HISTORIC AND DESIGN REVIEW COMMISSION

September 16, 2020

HDRC CASE NO: 2020-391
ADDRESS: 212 N ALAMO ST
LEGAL DESCRIPTION: NCB 425 BLK 23 LOT W 43 FT OF N 89.6 FT OF 2
ZONING: D, H
CITY COUNCIL DIST.: 1
LANDMARK: YWCA / Henry Terrell Building
APPLICANT: Mark Henderson
OWNER: Chris McMartin/ALAMO QOZB LLC
TYPE OF WORK: Repair and maintenance, addition, storefront installation
APPLICATION RECEIVED: August 28, 2020
60-DAY REVIEW: Not applicable due to City Council Emergency Orders
CASE MANAGER: Edward Hall

August 25th, 2020
HDRC Final Approval Application
212 North Alamo Street – Henry Terrell Building

10 AWNING ELEVATION - TYPICAL
SCALE: 1/2" = 1'-0"

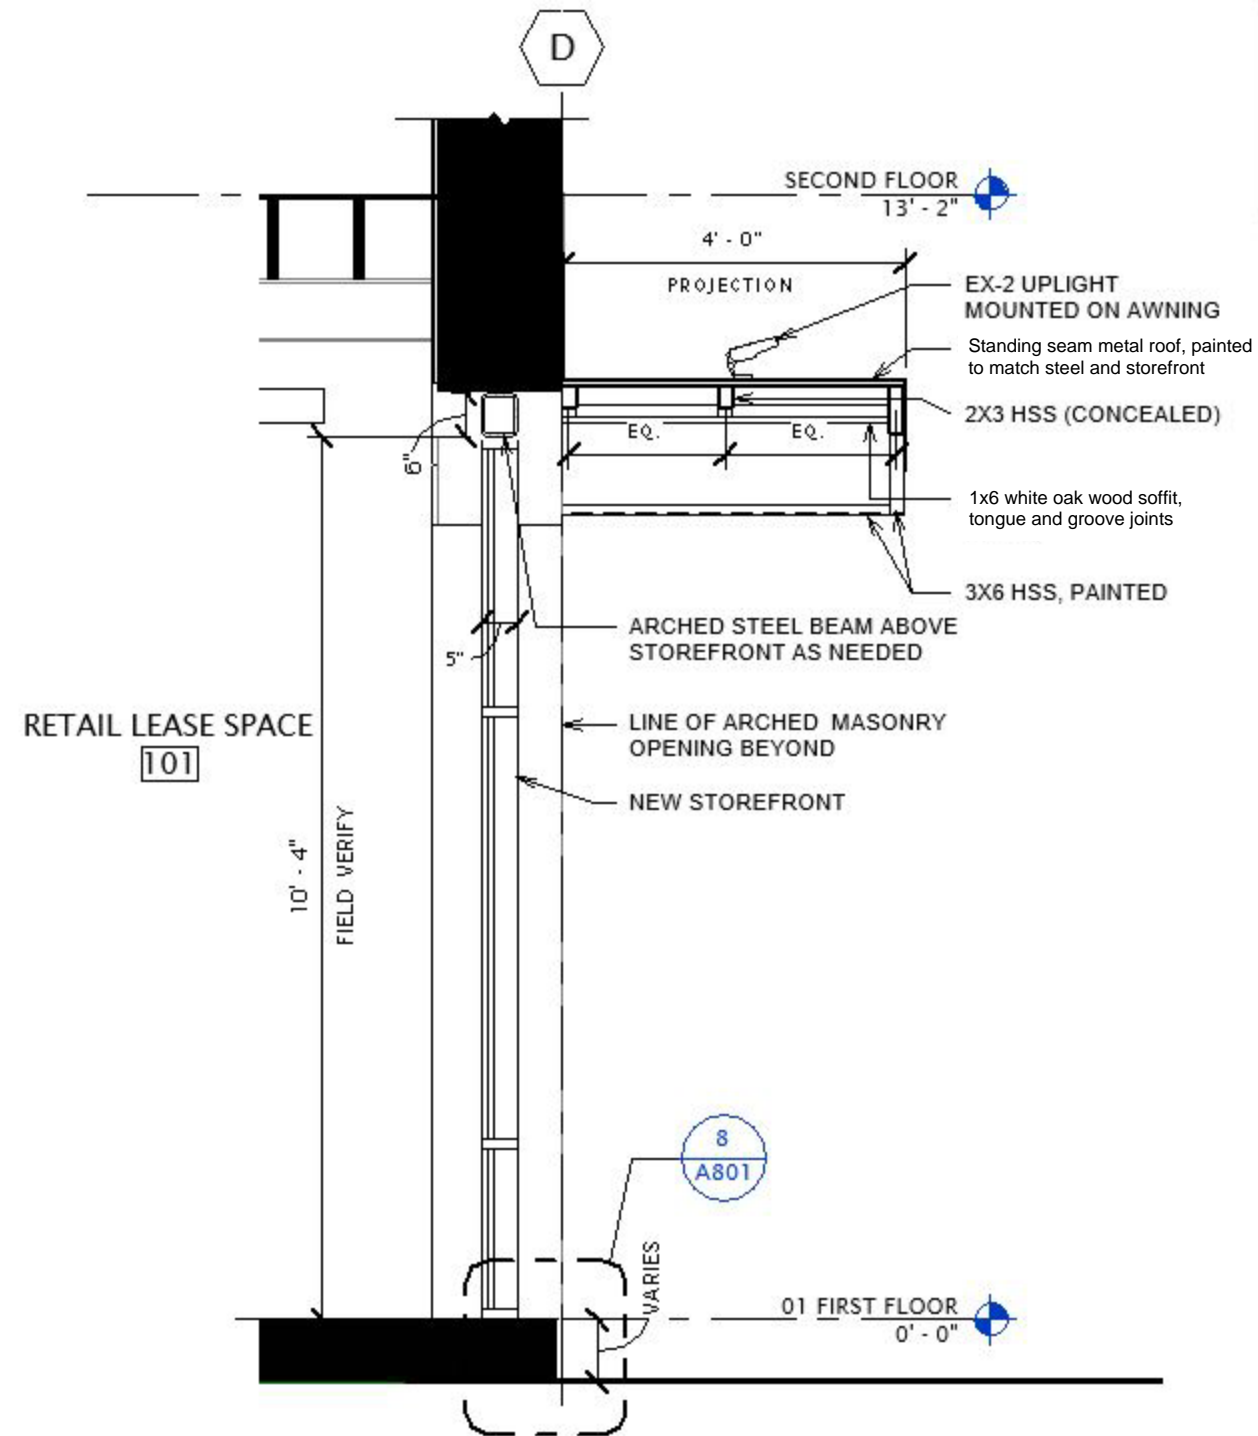
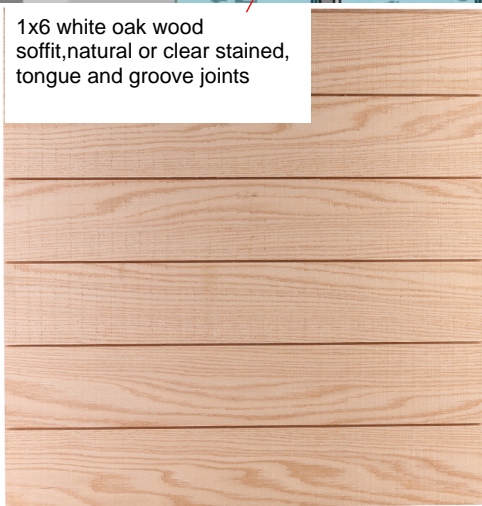
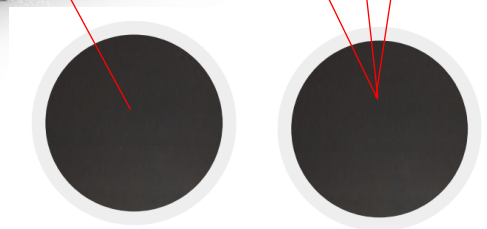
- j. **CANOPIES** – The applicant has proposed to install curved steel canopies above the five arched storefront profiles on the N Alamo façade. The Guidelines for Exterior Maintenance and Alterations 11.B.ii. notes that new canopies and awnings should be based on accurate evidence of the original, such as photographs. If no such evidence exists, the design of new canopies and awnings should be based on the architectural style of the building and be proportionate in shape and size to the scale of the building façade to which they will be attached. Staff does not find the proposed canopies to be consistent with the Guidelines as there is not information to support the proposed profile and materials, standing seam metal roofs and wood soffits. Staff finds that coverings similar in profile and material to those noted in the historic photograph would be more appropriate.

Staff does not recommend approval of item #7, the installation of curved entrance canopies as proposed. Staff recommends that the applicant install an alternative covering that is more consistent with historical evidence.
